**Project: IEEE P802.15 Working Group for Wireless Personal Area Networks  
(WPANs)**

**Submission Title:** assigned comments for draft D2

**Date Submitted:** September 2010

**Abstract:** proposes comment resolutions for a set of CIDs

Split Figure 23 into Figure 23 (a) and Figure 23 (b)

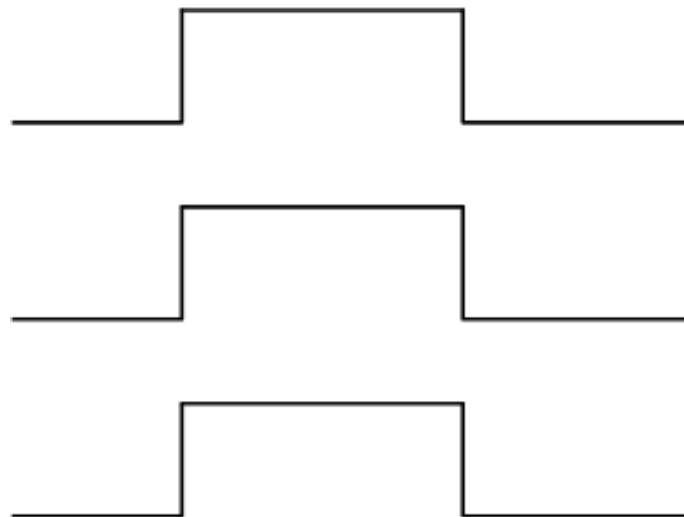
# T-CID 63 – Assignment

Accepted in principle. Three action items here (assigned to Sridhar) ...

1. Split option field into 4 fields for OOK and 1 CES field for PHY III

2. Answer the question "does dimmed OOK apply to PHY III

3. Clarify text to indicate that the CES option field is turned on by reading the MCS ID.

Add following text on Pg 37, line 16

- The options field in Figure 23 (a) shall be transmitted only if the dimmed OOK bit is set in the PHR.
- The options field in Figure 23 (b) shall be transmitted only if PHY III is selected based on the MCS ID chosen in the PHR.
- The dimmed OOK mode shall not be used with PHY III. i.e. both the option fields shall never be used simultaneously.

(a) Output from PHY SAP

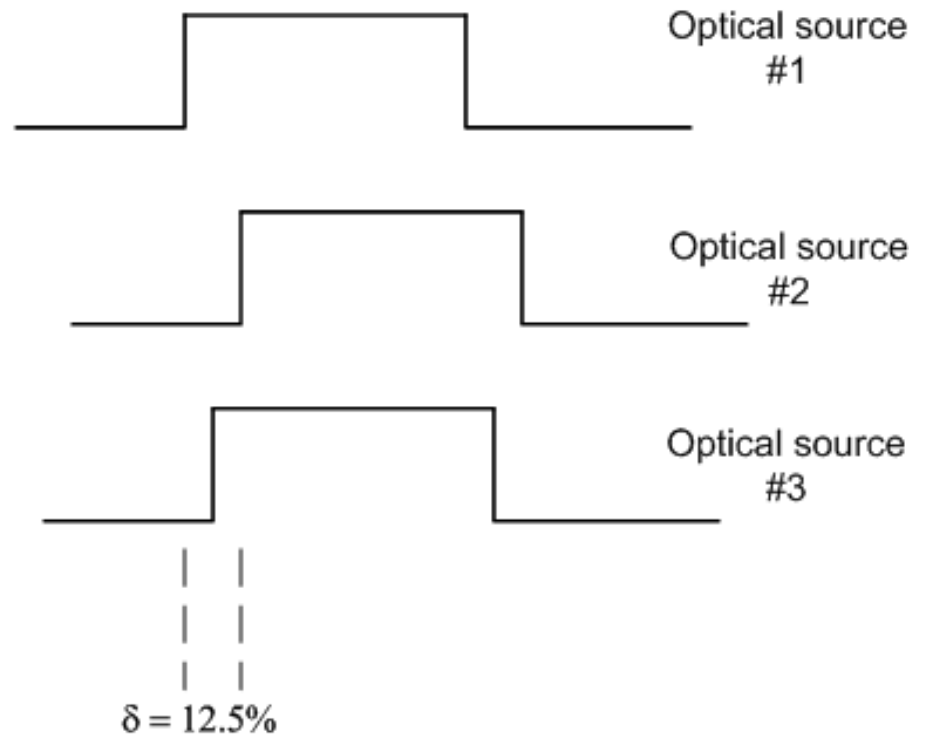
In the receiver side, ADC for PHY III should have at least 4 over times sampling rate to symbol rate.

For avoiding the degradation, the delay difference should be smaller than a half of the sampling period.

As a result, the allowable delay difference is  $1/8$  of the symbol duration. So,  $\Delta$  should be less than 12.5% of symbol clock.

Add subclause 5.1.x for “Maximum error tolerance for multiple optical sources”

Suggested text:

- If multiple optical sources are used, it is recommended the optical sources have similar frequency responses in order to assist communication. The digital input to all the optical sources from the PHY shall be synchronized. The maximum spread between the clock edges at the output of the optical sources shall not vary by more than 12.5%.
